Re: Remedial Investigation Addendum No. 3
Metropolitan Former MGP, Site# 224046

The Department has reviewed the Remedial Investigation Work Plan Addendum No. 3, dated May 13, 2011, submitted by National Grid. The Work Plan is hereby approved with the following modification:

Figure 1 Additional Soil Borings/MWs

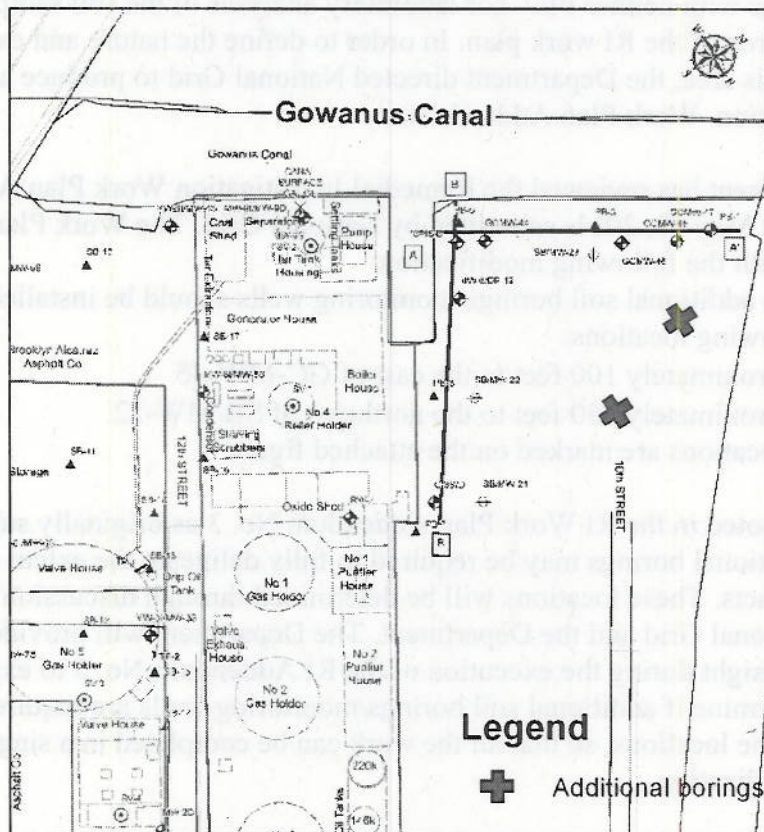
1. Two additional soil borings/monitoring wells should be installed at the following locations:
 - Approximately 100 feet to the east of GC-MW-45
 - Approximately 150 feet to the northeast of SB/MW-22.These locations are marked on the attached figure.
